W8485-237399/A

Title/Titre: Aviation Maintenance Stands Deployable and Spares	
Solicitation No – N° de l'invitation W8485-237399/A	Date 2022-11-23
Solicitation Closes - L'invitation prend fin at - à 14 :00hrs on - le 2023-01-03	Time Zone Fuseau horaire EST
Address Enquiries to – Adresser toutes questions à : Department of National Defence Ministère de la Défense Nationale National Defence Headquarters Quartier-General de la Défense Nationale MGen George R Pearkes Bldg Edifice Mgen George R Pearkes 101 Colonel By Drive 101 Promenade du Colonel By Ottawa, ON K1A 0K2 Ottawa, ON K1A 0K2	
Name : Viktoriya Anokhine Attn: DAP 4-4-2 Viktoriya.Anokhine@forces.gc.ca	
Destination of Goods and Services – Destination des biens et services : ATTN : CC130J WSM Det Trenton Building 52, Room 208D, 52 North Star Drive PO Box 1000 Stn Forces Astra, Ontario, K0K 3W0	
Instructions / Instructions: Municipal taxes are not applicable. Unless otherwise specified herein all prices quoted must include all applicable Canadian customs duties, GST/HST, excise taxes and are to be delivered Delivery Duty Paid including all delivery charges to destination(s) as indicated. The amount of the Goods and Services Tax/

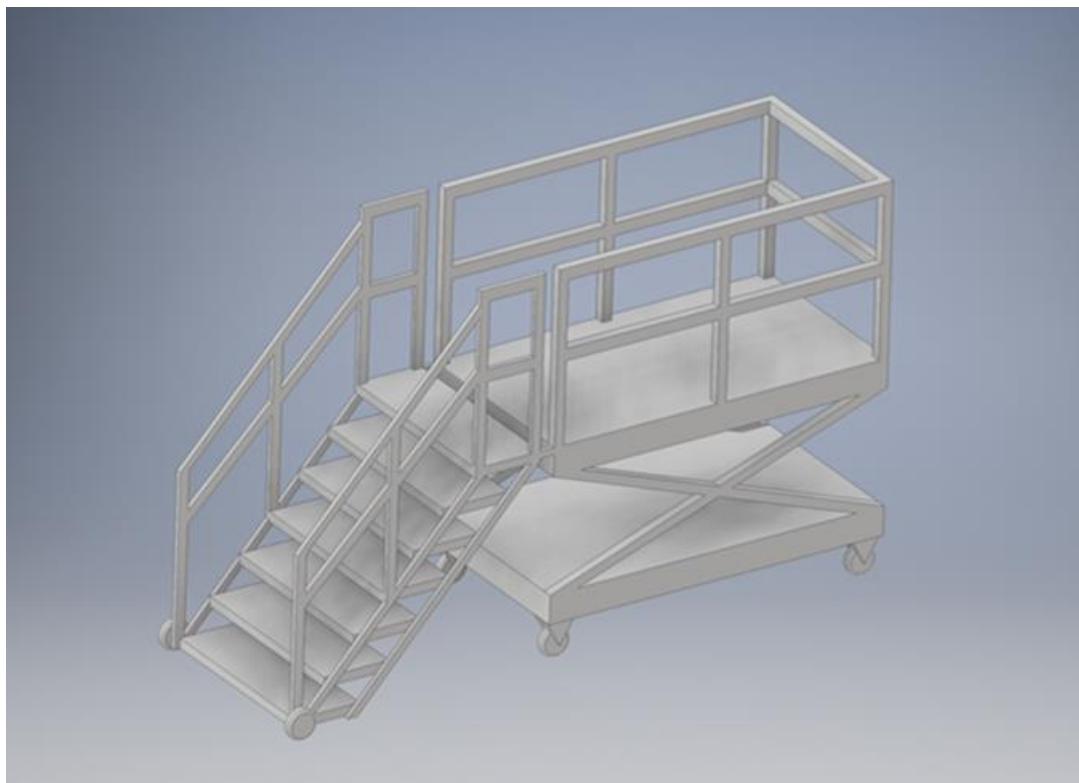
Question #1: Question regarding the "stairs". This 3 ft to 16 ft platform height is a very large range of travel. It states stairs and platform stay parallel at any height. I'm familiar with a pivoting staircase design that we can offer, but it would have to be very long to reach 16 ft high. That means when it's retracted down to 3ft, it's going to be very (dare I say, obnoxiously) long. Is that what they want?

Question #2: Section 2.0 it mentions the stairways again, but then says, "may be used to access the aircraft". That doesn't sound like the same pivoting staircase that would allow access from the floor.

Answer #1: Stairs are required, solution must allow for stairs to remain parallel (level to the platform) at all heights. If this results in a super long "tail" for the platform, then that is a potential solution. Key is that it has to be able to be reliable for towing requirements.

Answer #2: With regards to access to the aircraft, there is no requirement to be able to "walk into the aircraft" from the stand. There is just a need to be able to perform aircraft work from the stand.

Below is a concept sketch.
